Change Order Request

Williamson County Expo Center

Change Order Request: 007

Description	Category	Status
Required Life Safety Upgrades, Electrical Upgrades and Misc. Added Details	Contingency	New

TYPICAL LIGHT POLE DETAIL

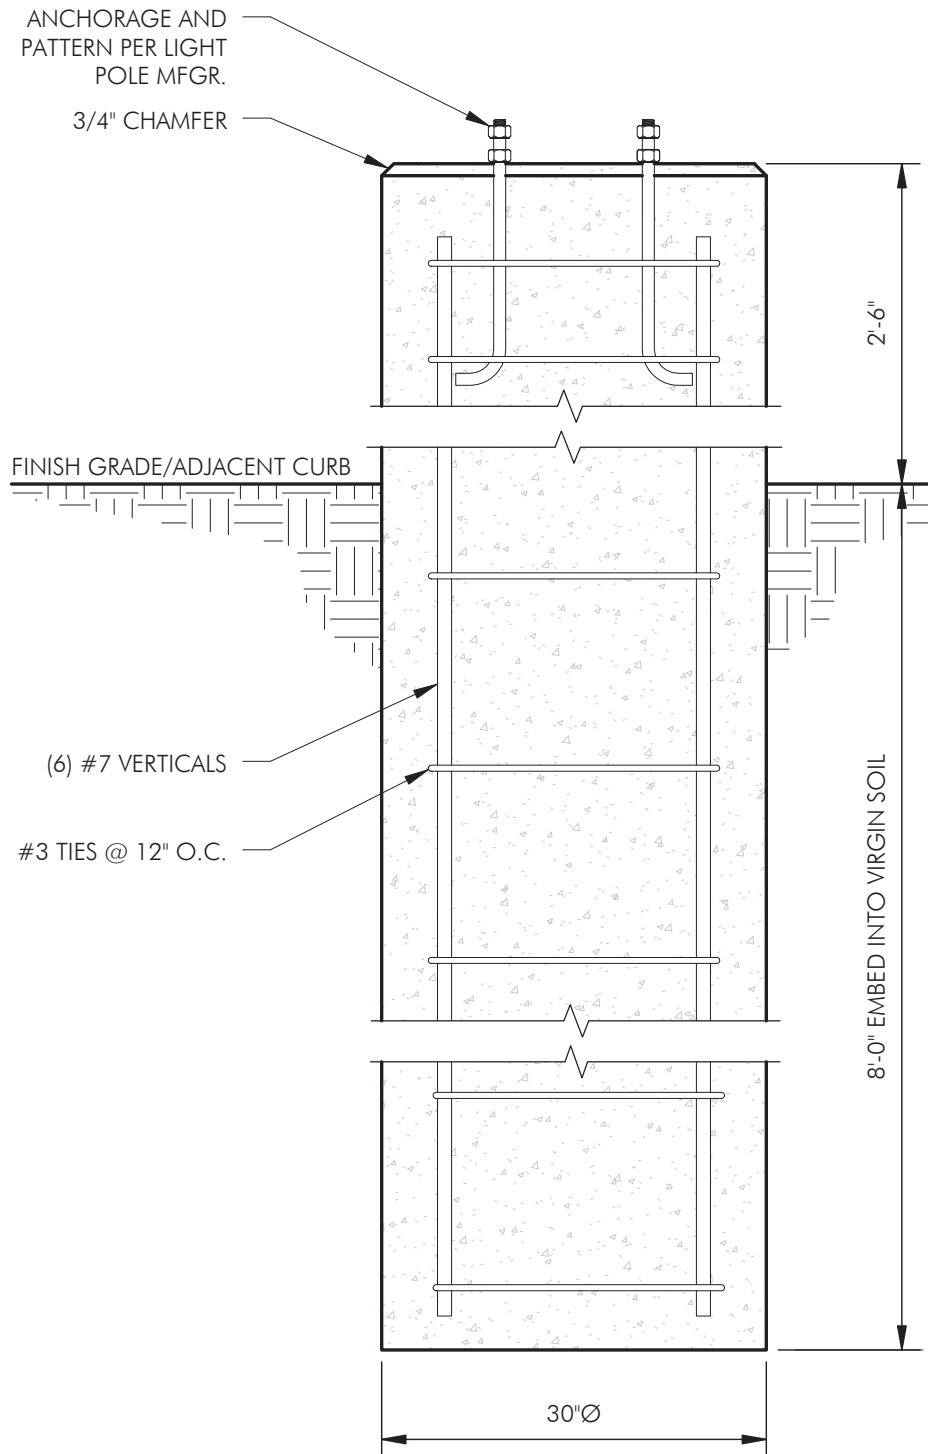
Price adjustment due to provided structural design for light pole bases per RFI 051. Original bid assumed bases were 24" dia x 11' OA height, 8' drill depth, 3' AFG. Reifoced with 6#6 vertical and #3 @ 12" oc ties. Revised design increases diameter to 30", increases vertical reinforcing to 6#7. Decreases OA height to 10'-6".

No structural detail was provided for new light pole bases. Please provide structural design detail for new light pole bases.

Attached is XS-02 for Site Lightpole bases.
Engineering 360, Inc

EXPO AREA
FOUNDATION PLAN

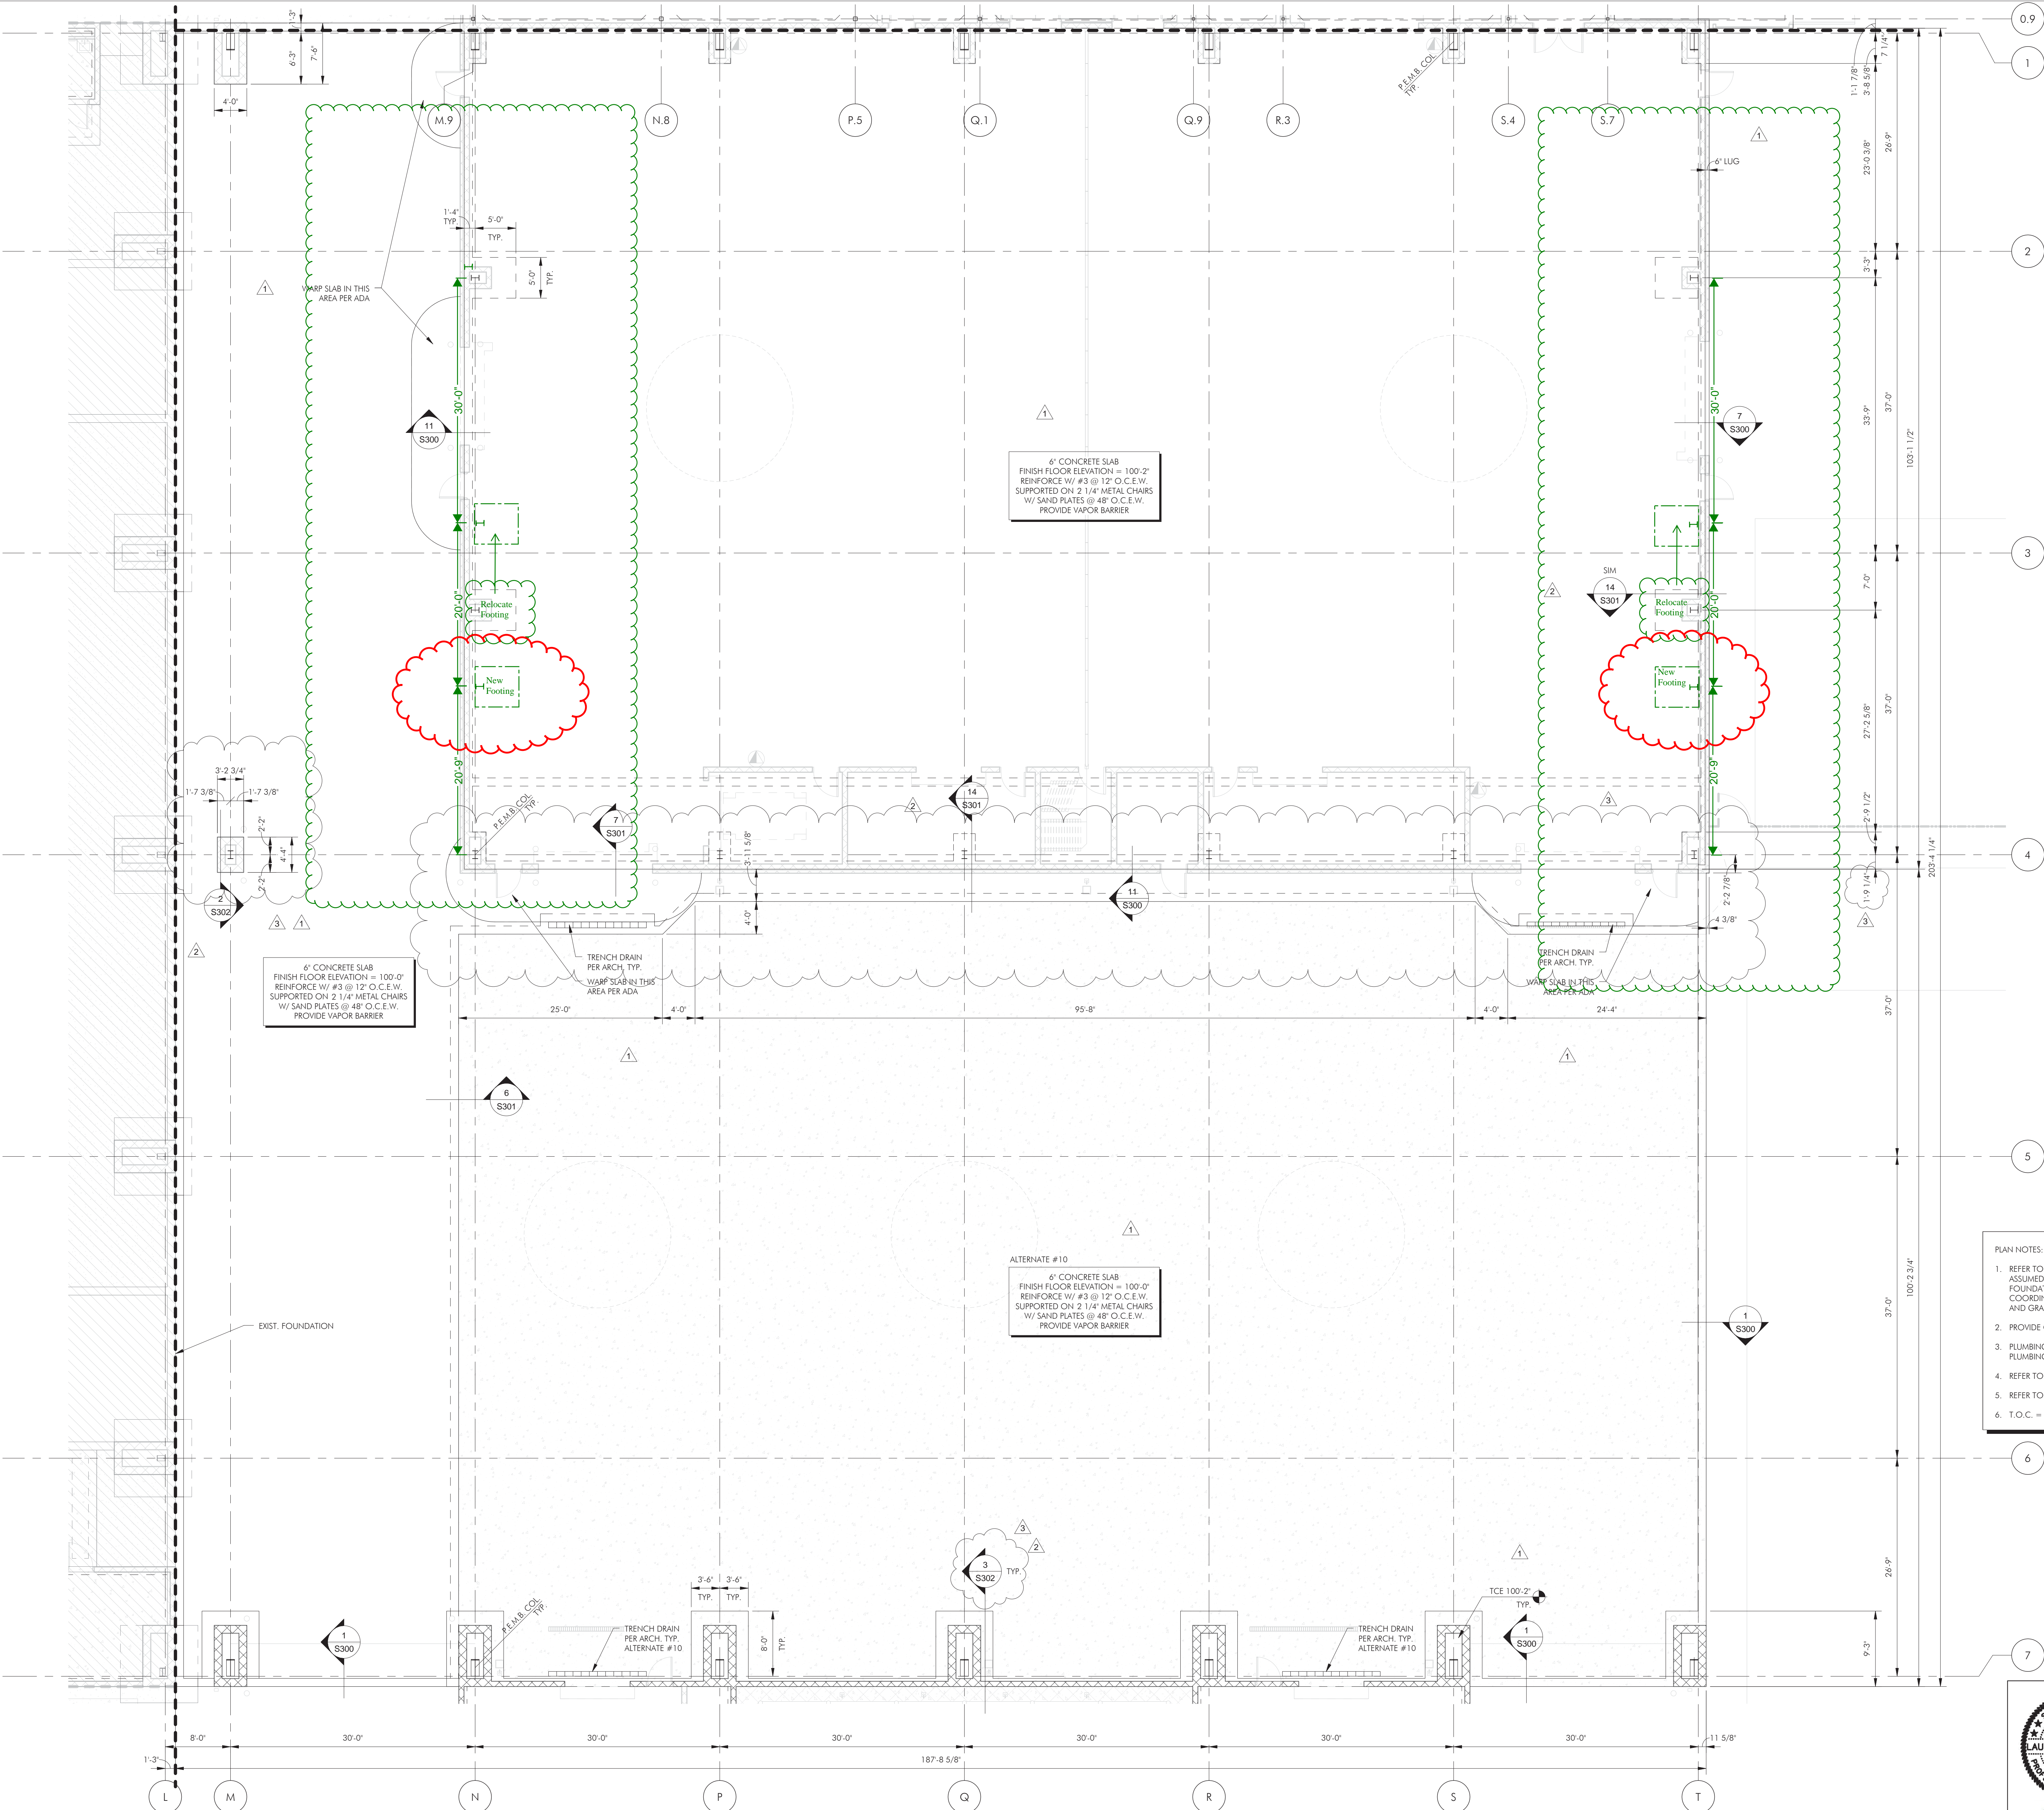
Add 2 spread footings per detail 14/S301 per RFI 058 due to PEMB manufacturer.

Pursuant to the limits of the Pre-Engineered Metal Building (PEMB), two PEMB columns were relocated and two additional PEMB columns were required to accommodate spacing limits. Please confirm the columns footings should be located per the attached annotated S102 drawing.

Please confirm the relocated and additional column footings should be constructed per typical detail 14 on S301.

Please confirm two additional column wraps shall be constructed as shown on A2-1A.

Columns and footings should be located per the attachment annotated S102 drawing.
Relocated and additional column footings should be constructed per typical detail 14 on S301.
Two additional column wraps shall be constructed as shown on A2-1A.

Interior metal wall panels and interior acoustical panels to be coordinated with new column locations.
Bill Bourne, Populous, 2/8/2016
